SERVICE BULLETIN

HONDA MARINE

OUTBOARD MOTOR #70
REVISED OCTOBER 2010

BF200A • BF225A (A2~AK0) HEATED OXYGEN SENSOR (HO2S) FAILURE

HO2S KIT INCLUDES:

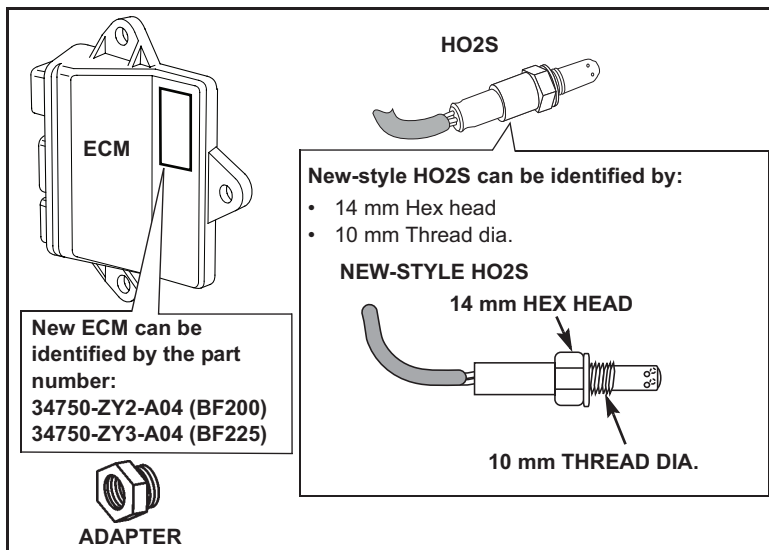
A new HO2S is available with a higher heat resistance. The ECM (Engine Control Module) must also be replaced because it has been reprogrammed to accept the new HO2S.

Install a new HO2S kit (A6 ~ AK0 units) on any unit with the described symptom following the procedure starting on page 4.

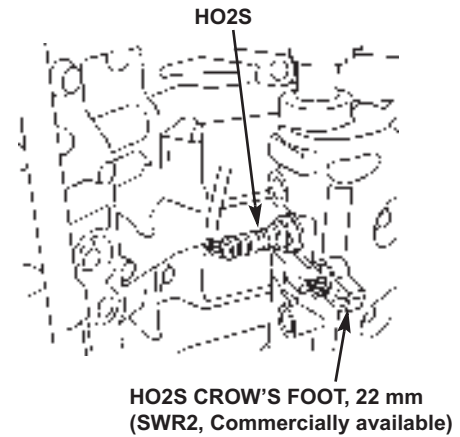
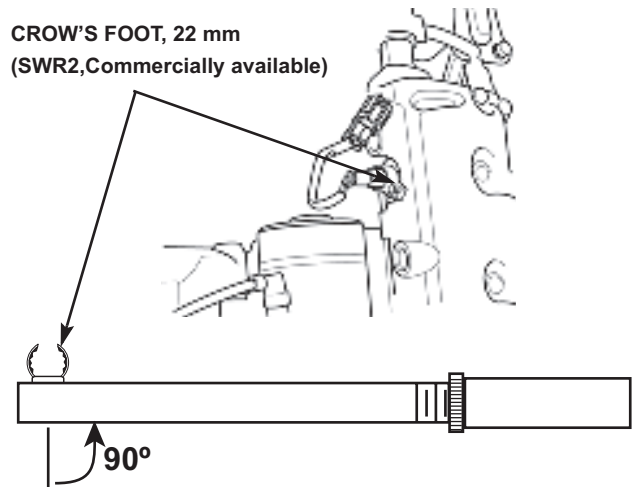
4. Remove the HO2S using a commercially available 22 mm HO2S Crow's Foot (SWR2) as shown.
5. Install the new HO2S by hand.

6. Tighten to the specified torque. Do not over-tighten. Attach the 22 mm Crow's Foot (SWR2) at a 90° angle to the body of the torque wrench as shown.

TORQUE: 42 N·m (31 ft·lb)

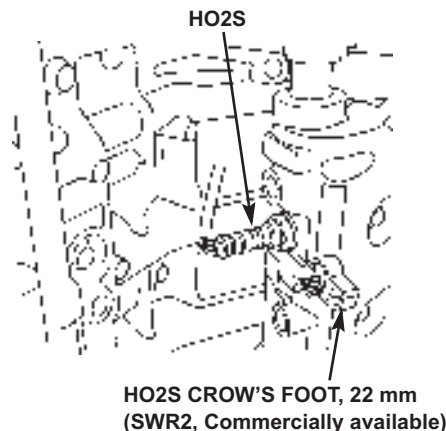
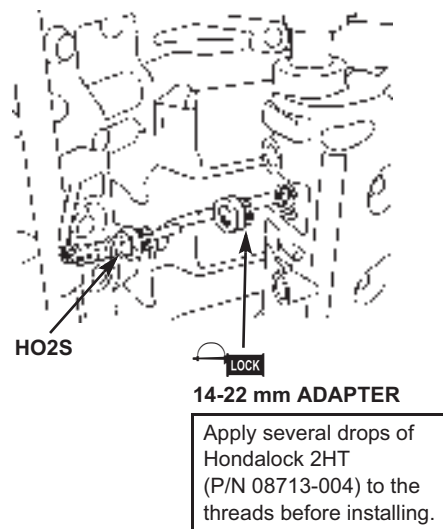
4. Remove the HO2S using a commercially available 22 mm HO2S Crow's Foot (SWR2) as shown.

5. Apply several drops of Hondalock 2HT (P/N 08713-004) to the HO2S 14-22 mm adapter.
6. Install the new HO2S 14-22 mm adapter and tighten to the specified torque.

TORQUE: 20 N·m (14 ft·lb)

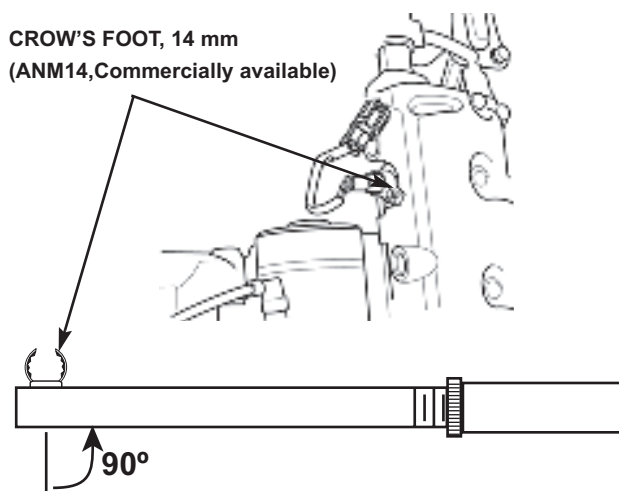
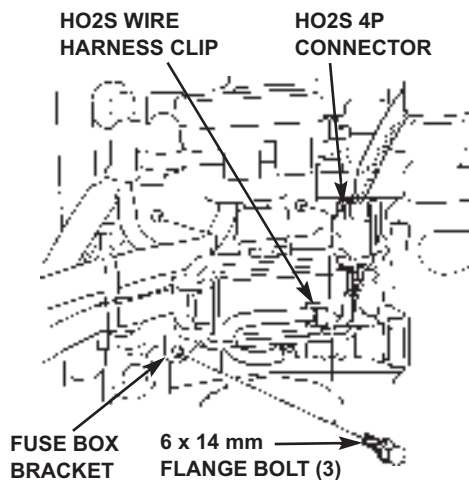
7. Install the new HO2S by hand. Do not apply Hondalock to the HO2S threads.

8. Tighten the new HO2S to the specified torque using the commercially available tool (ANM14). Attach the tool at a 90° angle to the body of the torque wrench.

TORQUE: 10 N·m (7 ft·lb)

ECM REPLACEMENT (A6 and AK0 Units)

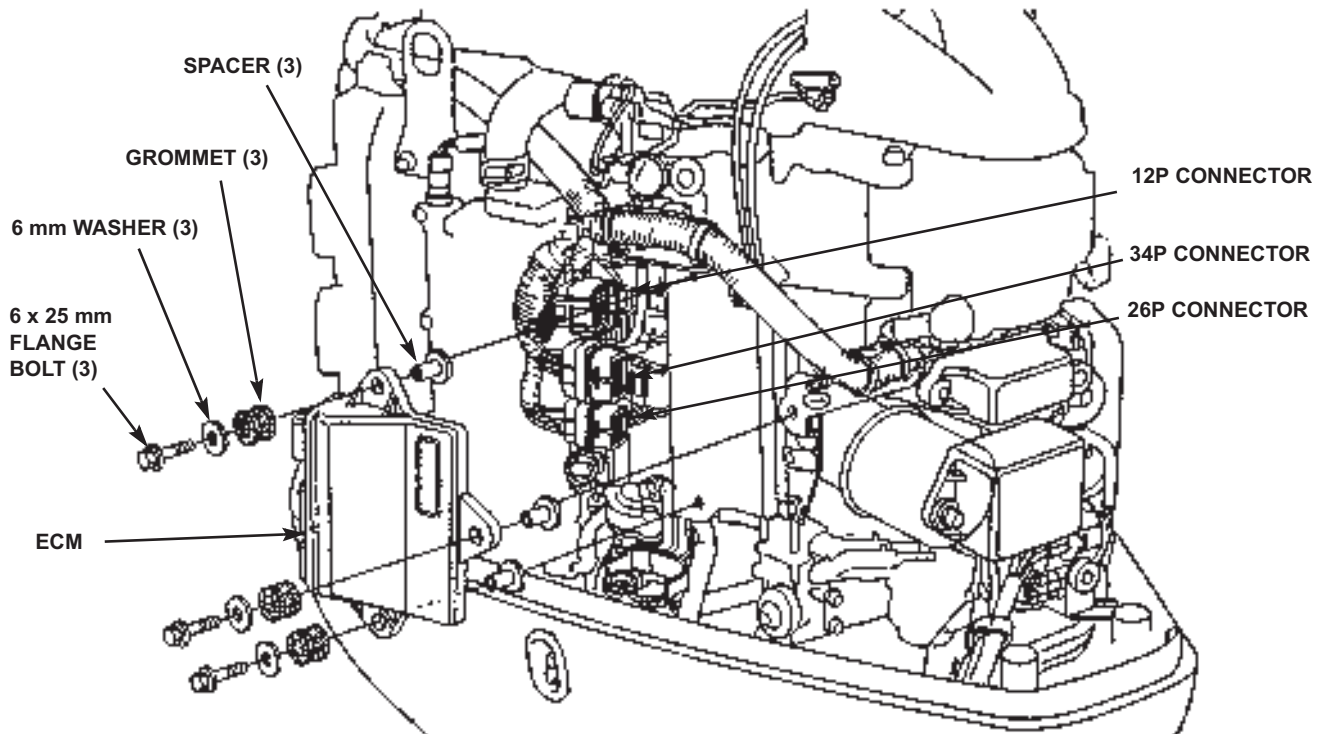
1. Remove the three 6 x 25 mm flange bolts and washers.
2. Disconnect the 26P, 34P, and 12P connectors from the ECM.
3. Remove the ECM.
4. Transfer the three grommets and spacers to the new ECM.
5. Install the new ECM in the reverse of its removal.
